Planning Decisions Committee

6.30pm, Tuesday 12 April 2022

1. This report provides the Planning Decision Committee with an assessment of a planning application submitted for 371-385 Gore Street and 195 and 197 Argyle Street, Fitzroy. The report recommends approval of the application subject to a number of conditions.

Figure 1: Tree outstand markup

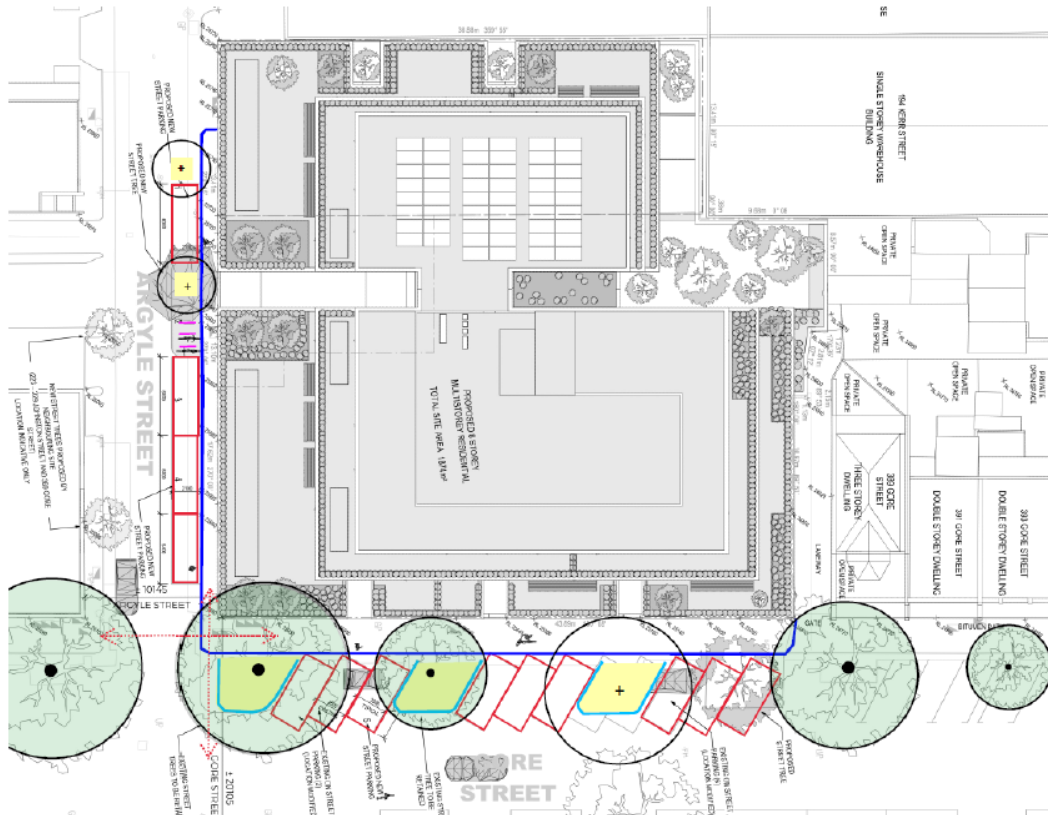
- The principle of providing more street trees is highly supported however the spacing and geometry of outstands needs to be revised. Spacing of outstands to be updated to provide continuous canopy coverage and reinforce the regular tree planting intervals along the western side of Gore Street rather than marking the building entry. There is also space for an additional road tree in Argyle Street. (refer to figure 1 markup)

- Geometry of outstands to be revised to maximise the efficiency of outstands and parking.(refer to figure 1 markup).
- Accessible east/west pedestrian connection across Gore Street at the Argyle Street intersection to be considered. Suggest kerb ramp provided at corner with outstand geometry revised to allow accessible pedestrian connection across Gore Street. (refer to figure 1 markup).

- Parking spaces and outstand on northern side of Argyle St are subject to truck turning circles entering and the Laneway to the south of Argyle St.
- Realignment kerbs for the proposed outstand along Argyle Street is likely to result in drainage issues. Council's preference is for the existing kerb alignment to be maintained with street trees and bike parking to be provided at road level or as a detached outstand. (refer to figure 1 markup and Council Civil comments)
